# **Agenda Item 7**

**2024/0005/DET**

**Representations – objection**

RE: Planning **objection** to [2024/0005/DET | Erection of 6no. houses \(3 blocks of semidetached\) | Land 65M South Of 22 Kerrow Drive Kingussie \(eplanningcnpa.co.uk\)](#) (Relevant also to: [2020/0013/DET | Erection of 22 apartments, formation of access road, SUDS, landscaping | Land 65M South Of 22 Kerrow Drive Kingussie \(eplanningcnpa.co.uk\)](#))

Figure 2: Strava heatmap of site

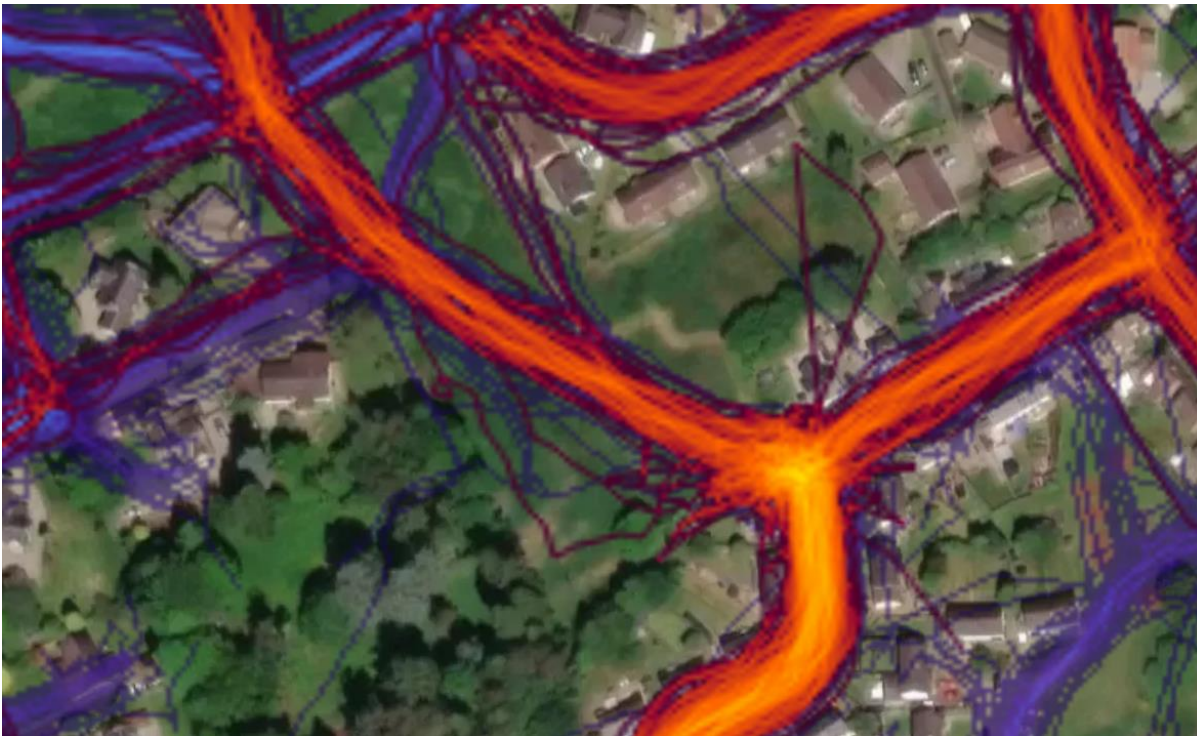
There is existing housing on all sides of the site which, while not currently densely packed, would become so following new housing construction on the site. The site itself is currently heavily used recreationally, along with Tom Baraidh to the north, as indicated by the Strava heatmapping below.
